# Service Bulletin

**Date:** January 2001  
**From:** Capstone Customer Service  
**Subject:** SSR Transient Voltage Suppressor Installation Instructions

The following graphic illustrates a typical SSR circuit diagram.

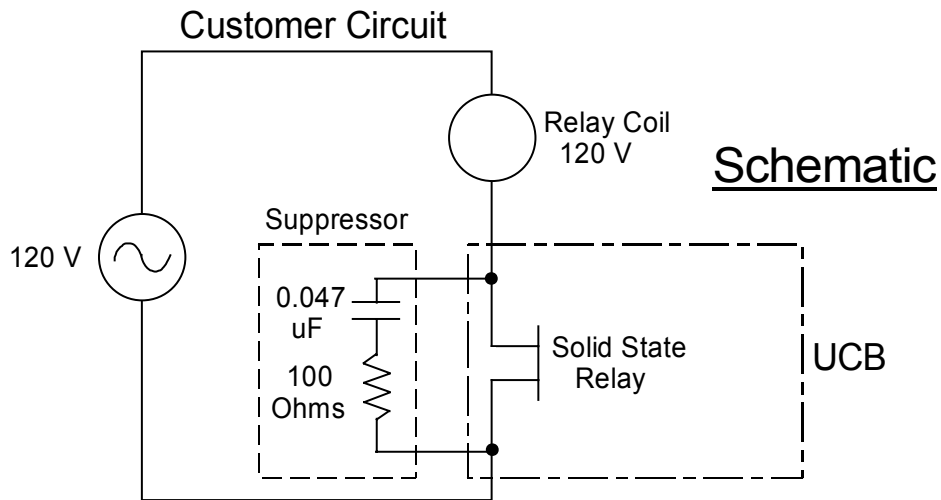
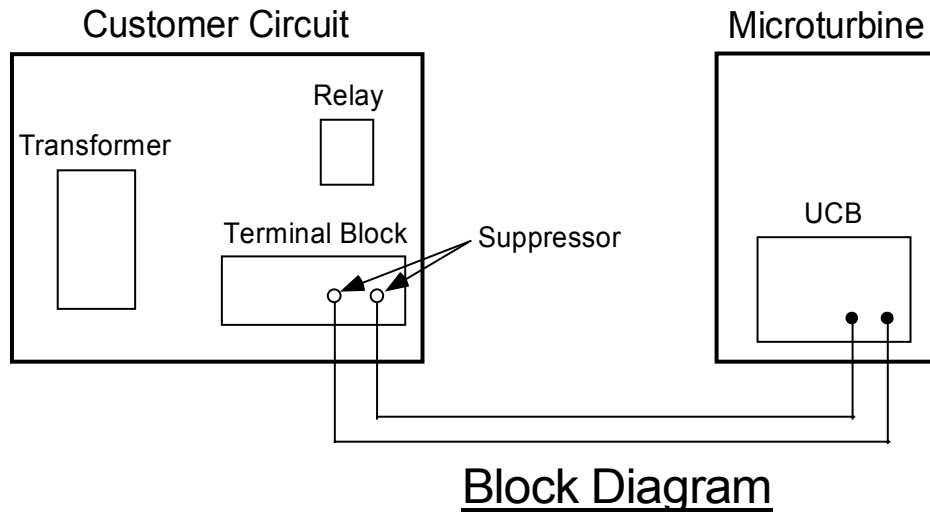
The SSR outputs in the UCB are rated at a maximum of 240 VAC (rms) under both steady state and transient conditions. The voltage across the solid-state relays in the UCB must **NEVER EXCEED 350 VOLTS PEAK**. Even transient voltages above this value may cause severe damage to the solid-state relay circuitry.

High peak voltages can occur in any circuit that contains inductive loads similar to relay coils, contactor coils, or electrical motors. These high peak voltages can occur even though the steady-state voltages may be within the 240 VAC limits.

In certain instances, Capstone has experienced failure of the SSR outputs, and therefore failure of the UCB circuit board when the SSR outputs were used to drive even a small 120 VAC relay coil. Failures have occurred at 5 VDC where the SSR output has directly driven a relay. In each of these events, the failure was due to a transient over voltage that occurred when the relay coil was being de-energized.

1. Suitable transient voltage (or contact) suppressors **MUST BE** installed in parallel with the SSR output whenever it is connected to a circuit that contains relay coils, contactor coils, or electrical motors. (Refer to the diagram on page 4).
2. If a transient voltage suppressor (an MOV or semiconductor) is utilized, it must have a maximum clamping voltage of less than 350 volts @ 100 milliamps. (Microsemi Corp. P/N 1.5KE300CA).

3. You may also employ an RC based contact suppressor. A suitable RC based device would have the following specific values: 250 VAC and 0.047uF at 100 ohms. Contact suppressor EVOX RIFA, Part Number PMR 209MB5470M100 may be used.
